Access Compliance Report

Public Rights-of-Way

Intersection ID: 16745	Main Street: MARYLAND_AV	Cross Street: PRINCETON_AV	Location: NE
ADA ID: 9EEA0E137A1E	Ramp Type: PerpDiag	Initial Pass/Fail: Fail	Overall Compliance: No
		Severity Score: 22.5

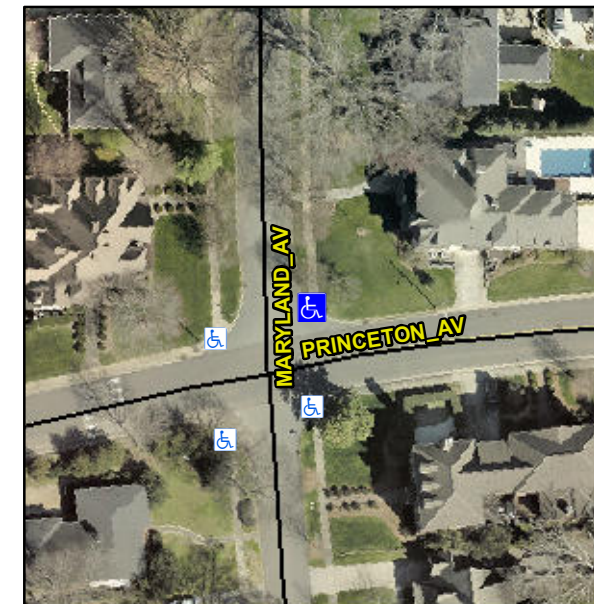
Not Found, R304.5.1, R304.2.2, R304.5.3

Compliance	Description	Data	Compliance	Description	Data
N/A	Ramp Length (in)	53.0	No	Ramp Slope (%)	10.4
No	Ramp Width (in)	39.0	No	Ramp XSlope (%)	2.3
N/A	Flare Type LT	N/A	N/A	Flare Type RT	N/A
N/A	Flare Slope LT (%)	N/A	N/A	Flare Slope RT (%)	N/A
N/A	Flare Traversable LT?	N/A	N/A	Flare Traversable RT?	N/A
N/A	Landing Length (in)	N/A	N/A	DWS Provided?	N/A
N/A	Landing Width (in)	N/A	N/A	DWS Contrast?	N/A
N/A	Landing Slope (%)	N/A	N/A	DWS Length (in)	N/A
N/A	Landing X Slope (%)	N/A	N/A	DWS Full Width?	N/A
N/A	Landing Curb? (Y/N)	N/A	N/A	DWS Offset (in)	N/A
N/A	Shared Landing?	N/A			
N/A	Gutter Ponding?	N/A	N/A	Gutter Slope (%)	N/A
N/A	Gutter Lip Ht (in)	N/A	N/A	Gutter X Slope (%)	N/A
N/A	Painted X Walk1?	No	N/A	Painted X Walk2?	No
	X Walk 1 Direction	To W		X Walk 2 Direction	To S
N/A	X Walk 1 Width (in)	N/A	N/A	X Walk 2 Width (in)	N/A
	X Walk 1 Slope (%)	2.1		X Walk 2 Slope (%)	0.6
	X Walk 1 X Slope (%)	1.4		X Walk 2 X Slope (%)	2.1

Remove & Replace Curb Ramp With Two New Directional Ramps or Equivalent.
